ADDENDUM NO. 2

AIR TRAFFIC CONTROL TOWER RADIO, COMMUNICATION AND ELECTRONIC UPGRADES

BOCA RATON AIRPORT

July 27, 2022

W502 - Revised nomenclature describing rack mounted radio transcivers.

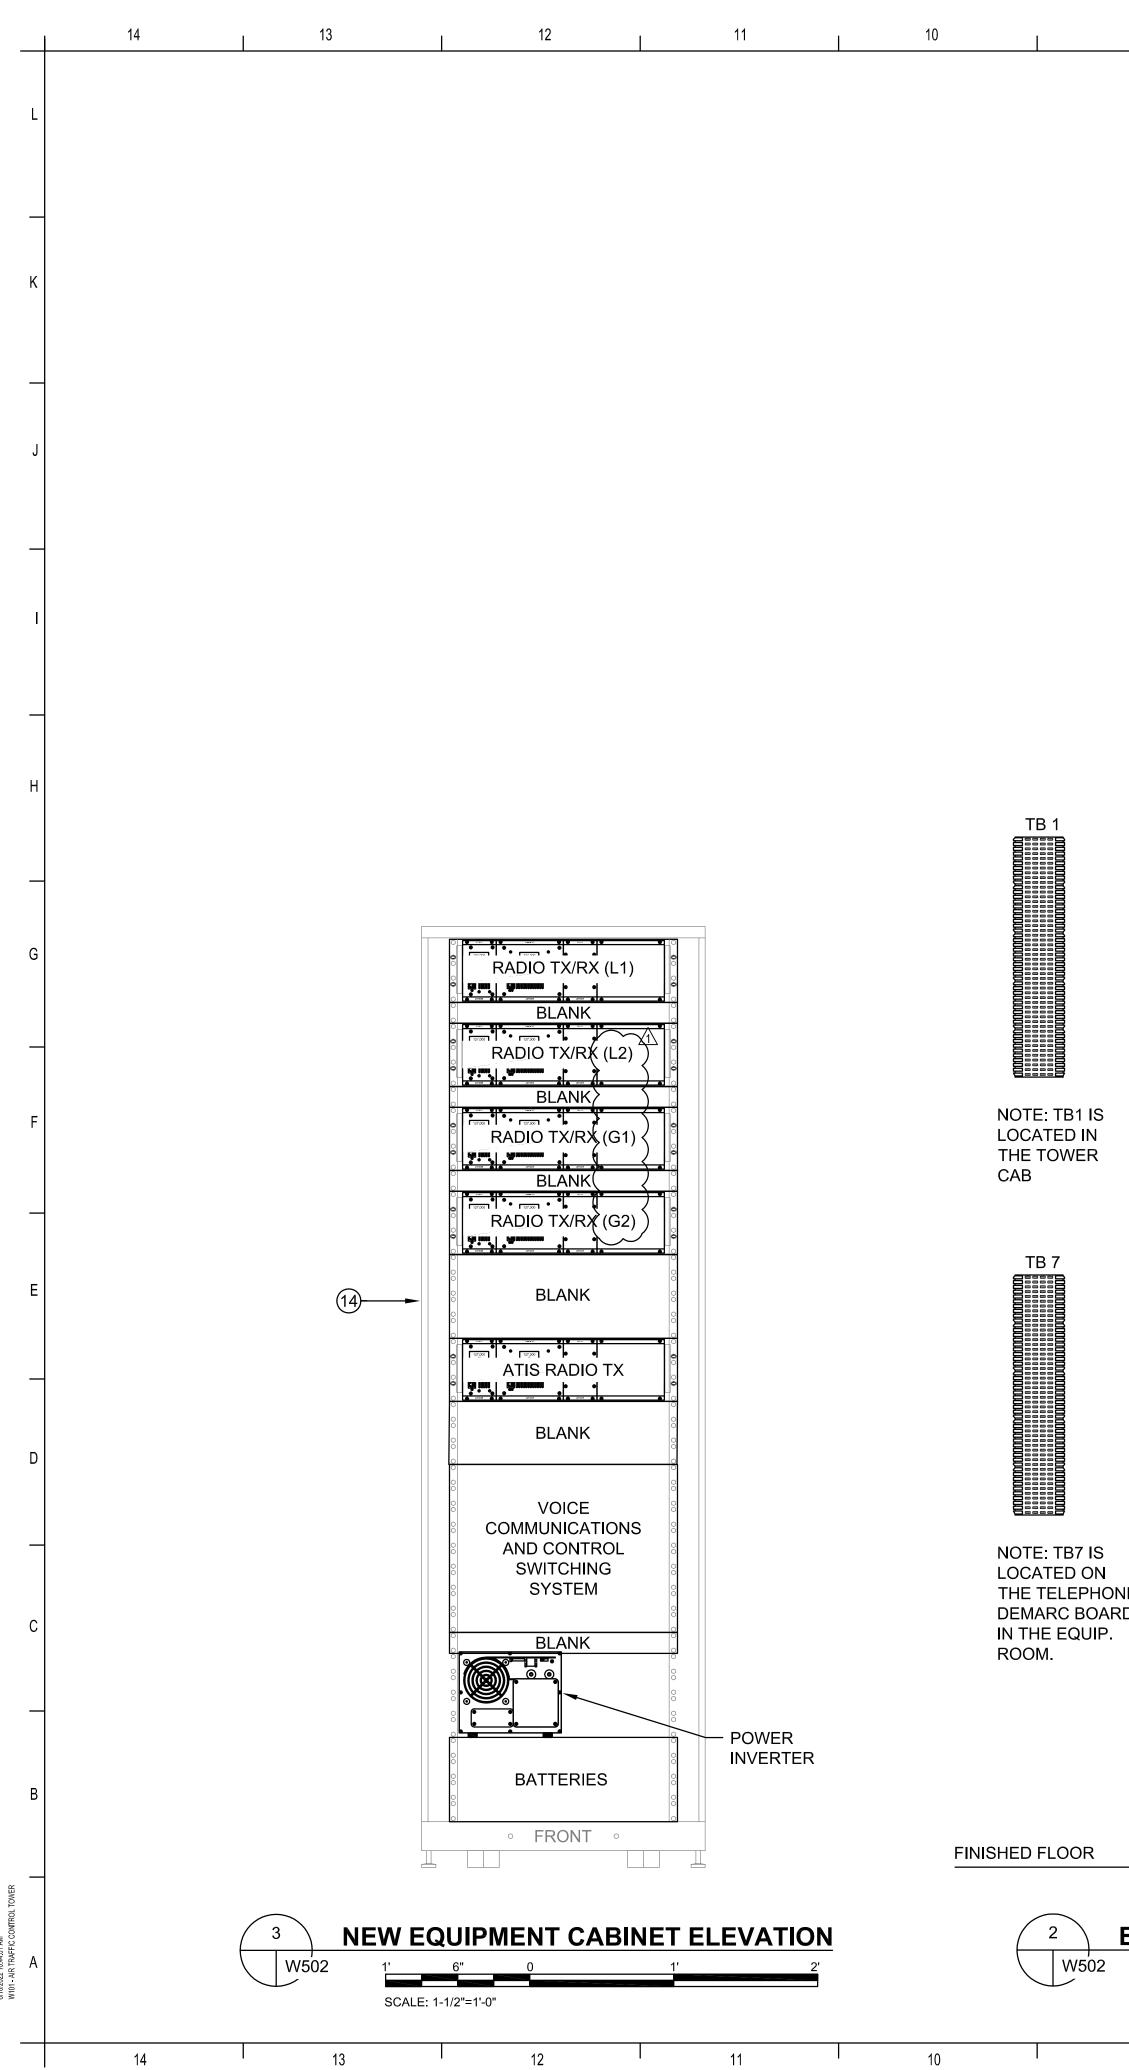
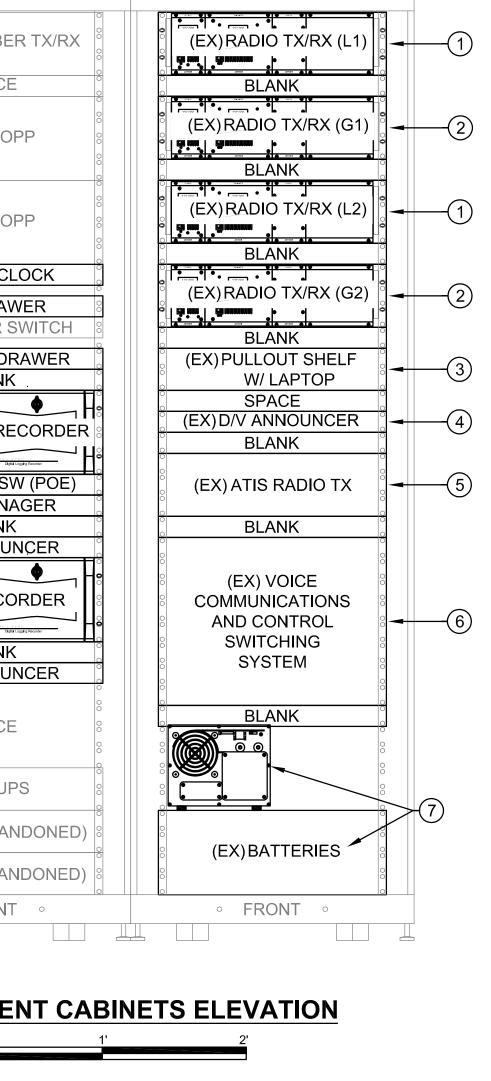
- **A:** Yes, the bidder is responsible for the requirements of all sections including section 27 05 28 (Pathways for Communications Systems General) as they pertain to the work shown on the bid documents.
- 6. In Project Manual, Section 27 32.43, Par 2.2 B. Discrepancy of how many radios. It calls for 2 each of VHF Transmitters and 2 each of VHF Receivers, and 1 VHF Transmitters for ATIS, then says five (5) transmitters and four (4) receivers. Please clarify?

A: Each ATC frequency shall have primary and secondary TX/RX. Refer to revised sheet W502 attached.

Local (118.425 MHZ) requires two (2) TX and RX. Ground (121.8 MHZ) requires two (2) TX and RX. ATIS (121.125 MHZ) requires one (1) TX. Total - five (5) transmitters and four (4) receivers.
